Auckland Transport Comments on Milldale North Fast Track Referral Application FTAA-2511-1142

Attachment to AT comments – Memo from PTM Consultants

Subject: Milldale North Fast Track Pre-referral Information

Figure 2: Excerpt from masterplan showing what appears to be a roundabout at one of the proposed crossroads intersections.

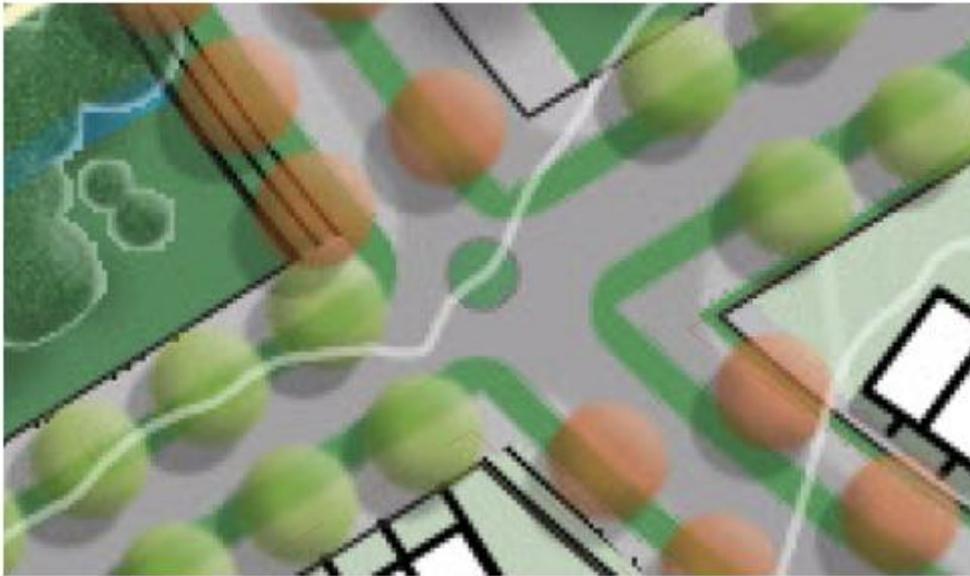
8. Where crossroads are proposed the preferred intersection treatment is a roundabout. For intersections on collector or arterial roads a compact roundabout design (where the central island has a mountable apron but is not necessarily fully mountable) is appropriate. Where the intersection is of two local roads a mini-roundabout design with a fully mountable central island is appropriate. The masterplan drawings show green circles at many of the intersections, which appear to be intended as roundabouts. However, they are not labelled, included in the drawing legend, or discussed in the documents accompanying the masterplan so it is not certain if these circles do indeed indicate the location of proposed roundabouts are or are indicate only. An excerpt from the masterplan showing an example of one of the presumed roundabouts is shown below in Figure 2.

9. I note that not all crossroads intersections shown in the masterplan have the circles presumed to indicate a roundabout.
10. Milldale Central to the south and east of the site has many examples of both compact and mini-roundabout designs which can be adapted for the Milldale North site.
11. Left-in/left-out (LILO) only treatments should be used on arterial road intersections with local roads where there are roundabouts located close by in either direction. I have shown an example of this in Figure 3.
12. A raised intersection treatment can also be considered for the intersection of two local roads where there is a [cross-road](#).
